DATE: September 15, 2025

PROJECT: City of Oxford
Oxford Park Place Restroom Facility

ADDENDUM NO. 1

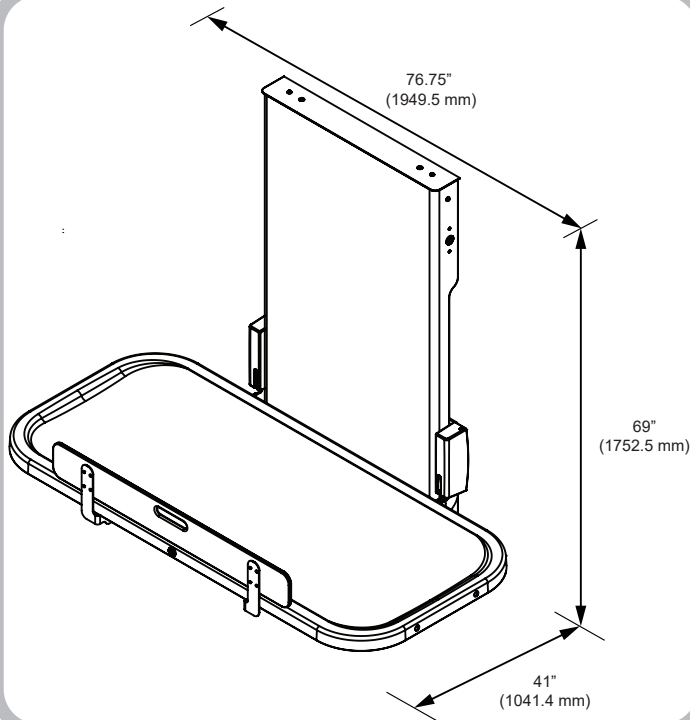
6. City of oxford will allow material storage and/or a storage unit to be set within the park construction area of work.

a. Contractor responsible to protect existing landscaping and structures.

b. Contractor to return area to existing condition at close of project.

7. Existing trees, to remain, located within the Area of Work shall be protected at the trunk with 2x4 lumber secured with #9 wire

Installation Information

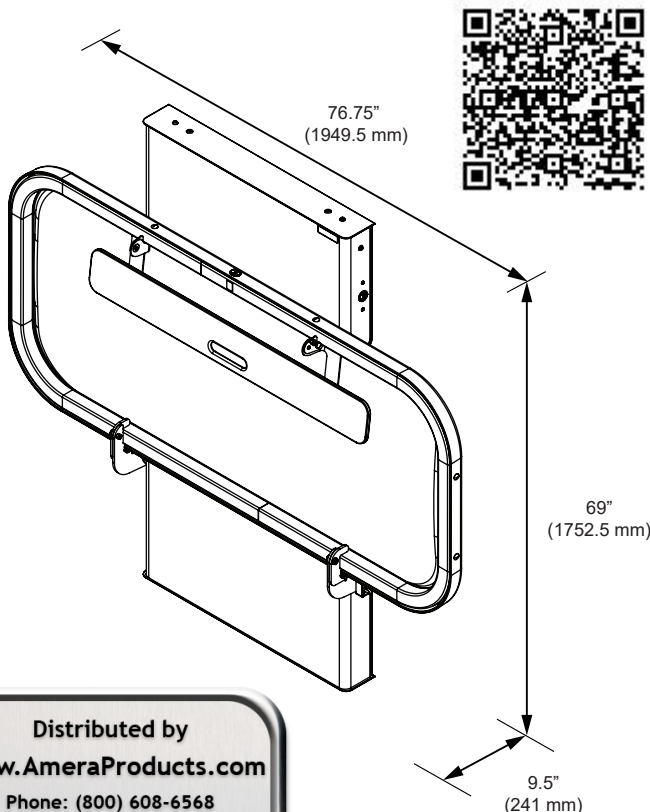
- a. **Q.** Who will file a building permit?
A. App Architecture.
- b. **Q.** Wind screen required on fencing?
A. No.
- c. **Q.** Cut Sheet for Adult Changing Station?
A. See attached.

- Reference Pre-Installation Guide and Assembly Instructions for more detailed information, including recommended blocking.
- Closed unit projects from wall 9.5 inches (241mm).
- Open changing surface projects 41" inches (1041.4 mm).
- Unit needs to be plugged into a 120v 20A GFCI outlet. To maintain a water ingress rating, ensure an appropriate While-in-use cover is installed.
